MEMORANDUM

To: Planning Commission
From: Doug Dansie, Senior Planner
Date: May 7, 2015
Re: PLNSUB2014-00522 Ken Garff Planned Development

To: Salt Lake City Planning Commission
From: Doug Dansie, AICP, 801 535-6182
Date: November 12, 2014
Re: PLNSUB2014-00522 Ken Garff Planned Development

**KEN GARFF DOWNTOWN BLOCK
CONCEPTUAL SITE PLAN
SALT LAKE CITY, UTAH
TAG 2024-014**

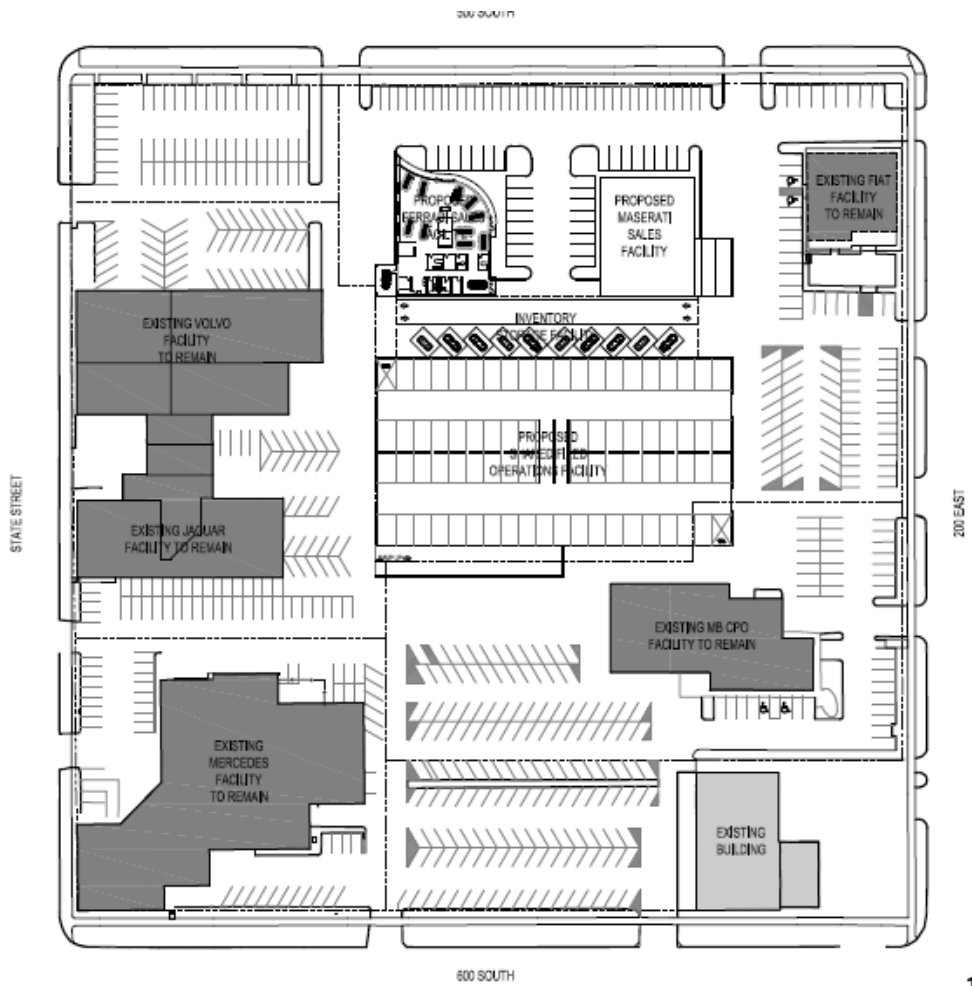
Recommendation: Landscaping requirements for the auto display area is not required. Landscaping for other areas, including parking, may be consolidated. Park strip trees are required, but spacing may be modified as per ordinance. There is no landscaped setback requirement from the front property line. (but the public park strip is to be landscaped).

Since there are street trees on three of the four block faces and 500 South has an extra wide park strip that would easily accommodate trees Staff recommends no modification to present code.

KEN GARFF DOWNTOWN BLOCK
 CONCEPTUAL SITE PLAN
 SALT LAKE CITY, UTAH
 24 MARCH 2015

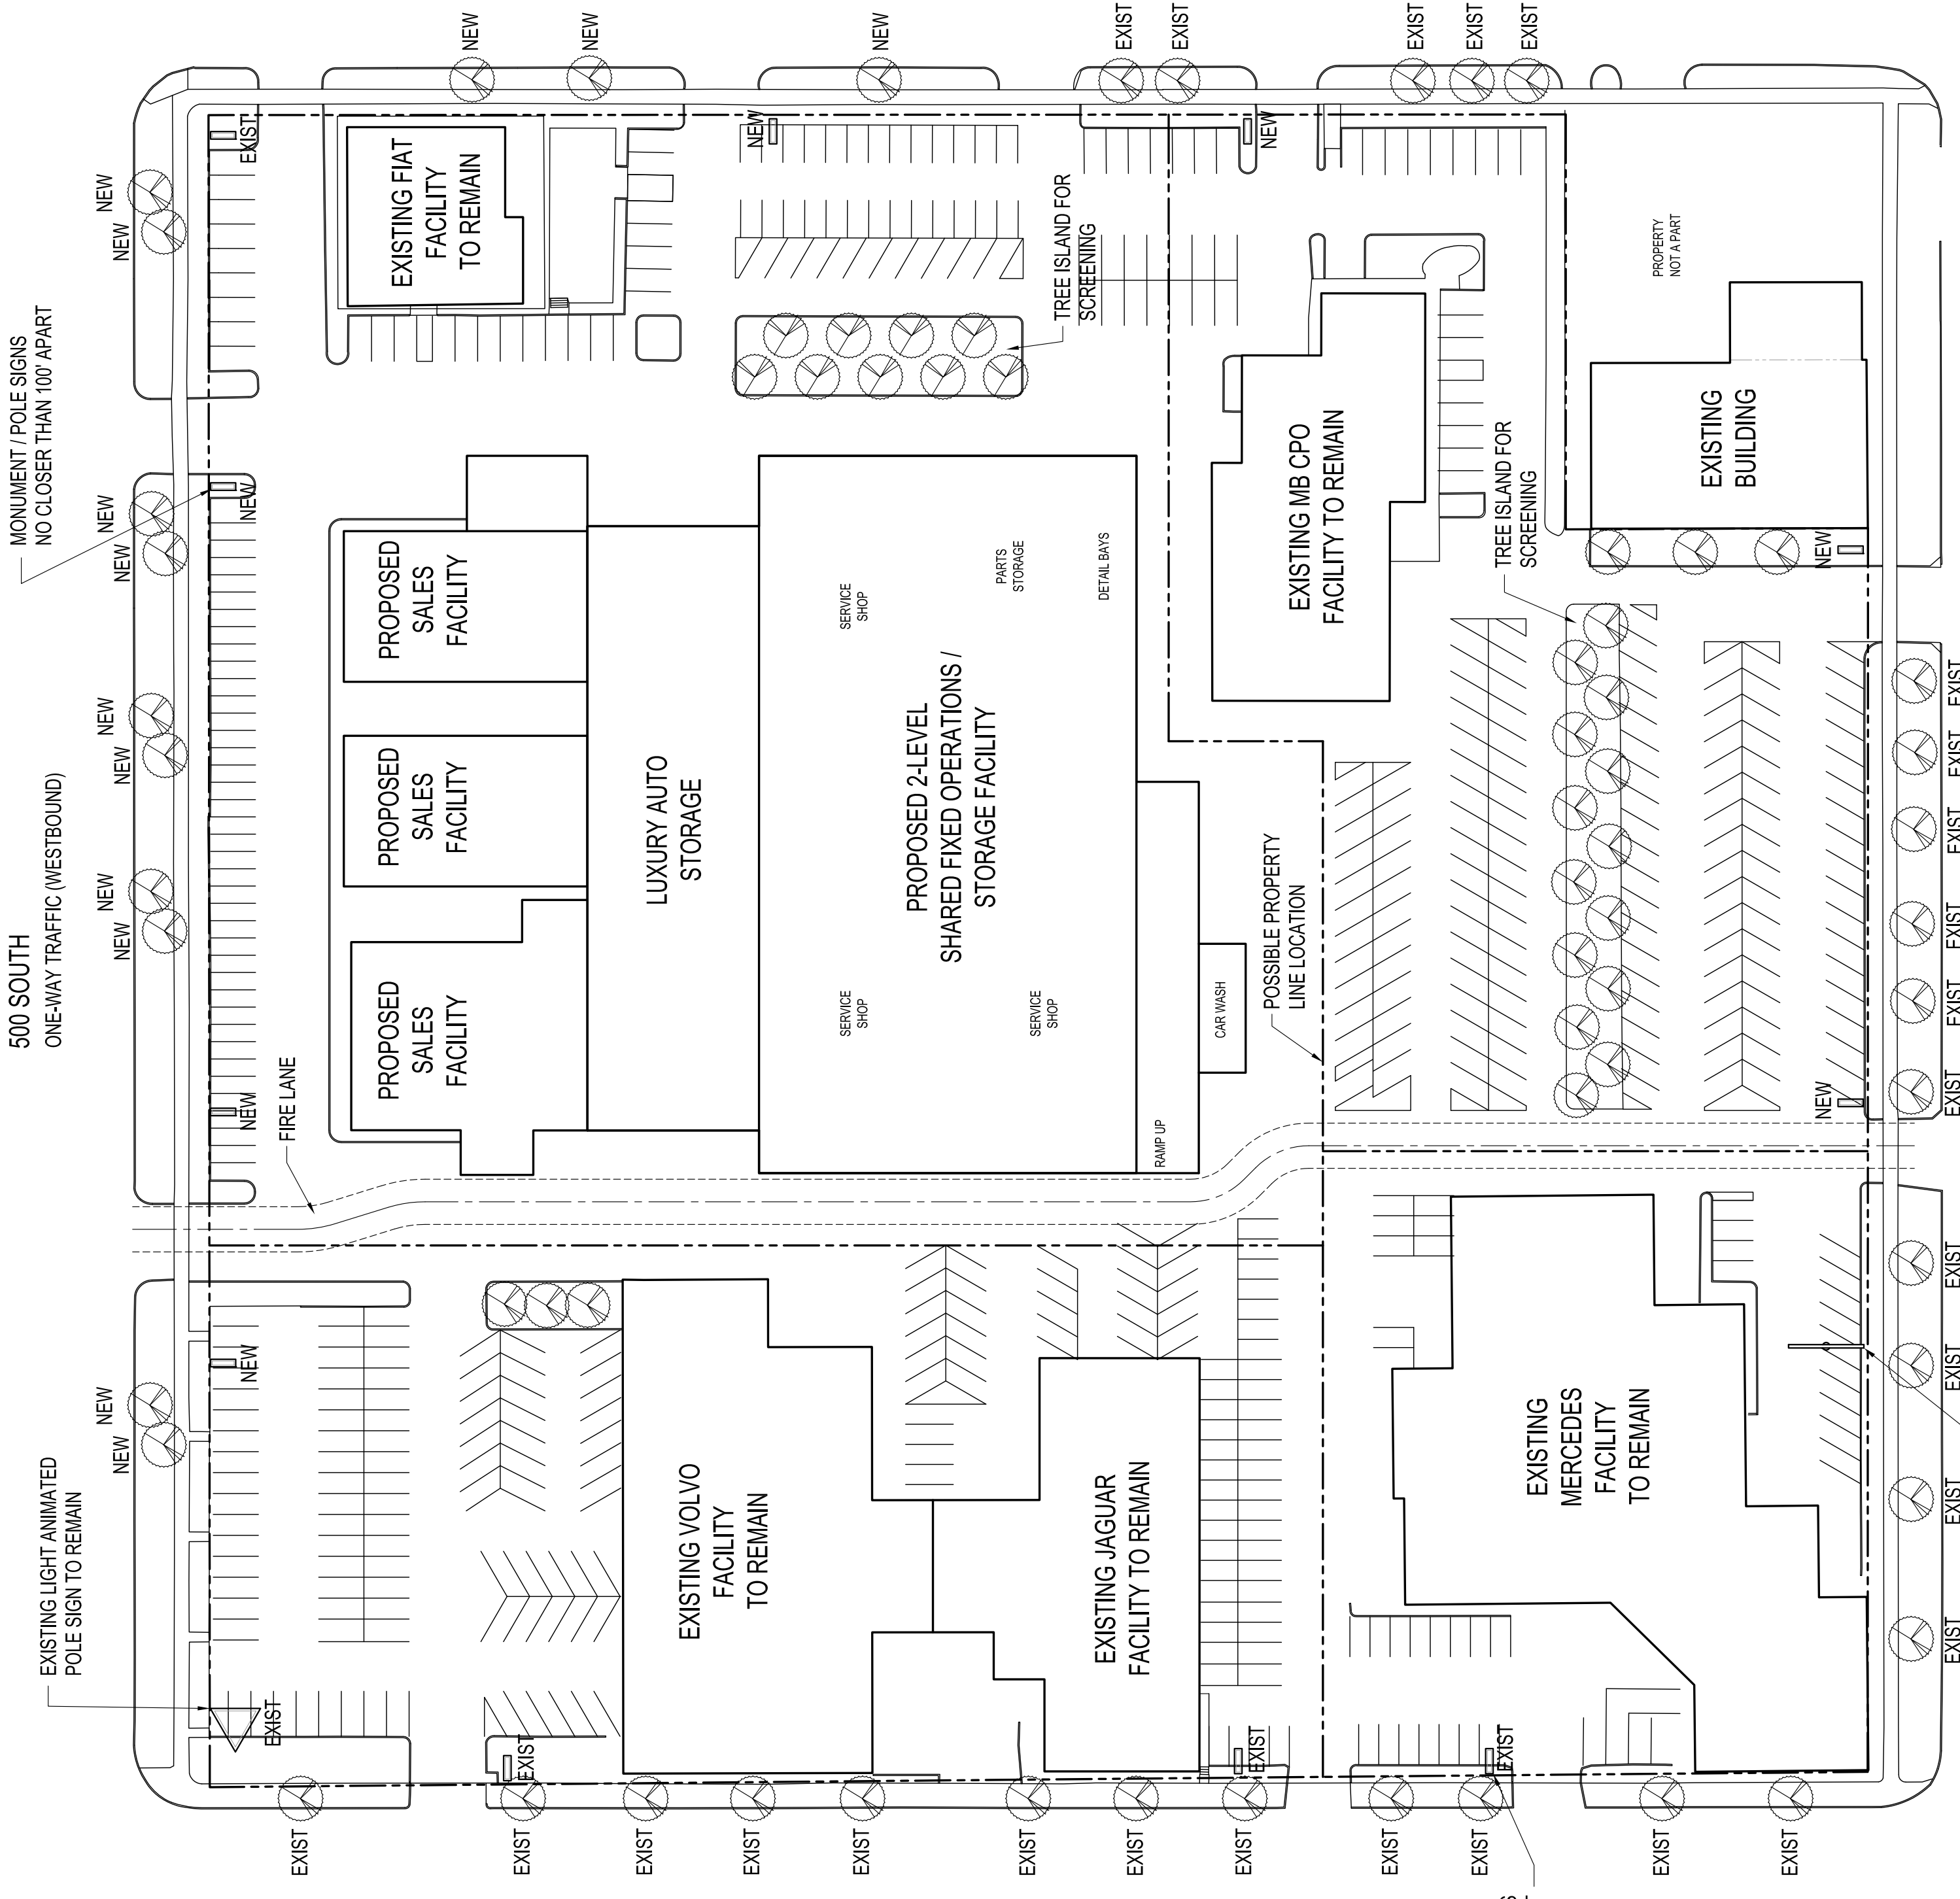
Tress: Garff is proposing that the number of future street trees be reduced by half. Staff has already recommended that trees not be required within the display area of the automobile dealership and that the remaining parking lot landscaping be allowed to be consolidated, rather than spread throughout surface parking. Staff has also acknowledged that the street trees can be adjusted to accommodate the neighboring architecture; however the original recommendation did not suggest a reduction in the number of trees or in the effect of creating a tree lined boulevard. As a practical matter, street trees are often reduced from required numbers due to driveway locations, utilities and other conflicts.

Street trees presently exist along State Street and the City Forester has offered to work with Garff to prune the trees to increase visibility. Street trees also exist on 600 South. There are also trees planted along most of 200 East. Therefore the primary effect of this change would be to future street trees to be located on 500 South, which ironically, is one of the two (along with 600 South) widest park strips on the block (both 500 and 600 South park strips are roughly 30 feet curb to property line as determined from aerial photos). 500 South is the most capable block face of accommodating larger street trees (the north side of 500 South also has the largest existing street trees across from any Garff property frontage). The counter proposal suggests installing only half as many street trees on 500 South (Roughly reducing the requirement from 19 to 10) and portions of 200 East.

Garff has suggested Frontier Elm as the tree, which is a medium size tree (up to 40 feet with age). Although it is good as a street tree and is on the Forester list, as a general rule larger trees (which canopy high) actually have less visual interference with adjacent businesses than small or medium trees do (which canopy at signage or display area level) . Staff suggests leaving final determination to the City Forester.

Staff is NOT recommending approval of the counter proposal and would support the original recommendation: Street trees are required as per city code (and location may be adjusted in consultation with the City Forester). If the Planning Commission wishes to accept the counter proposal, they should make specific findings based upon the standards listed in the original Staff report Attachment F: Analysis of Standards.
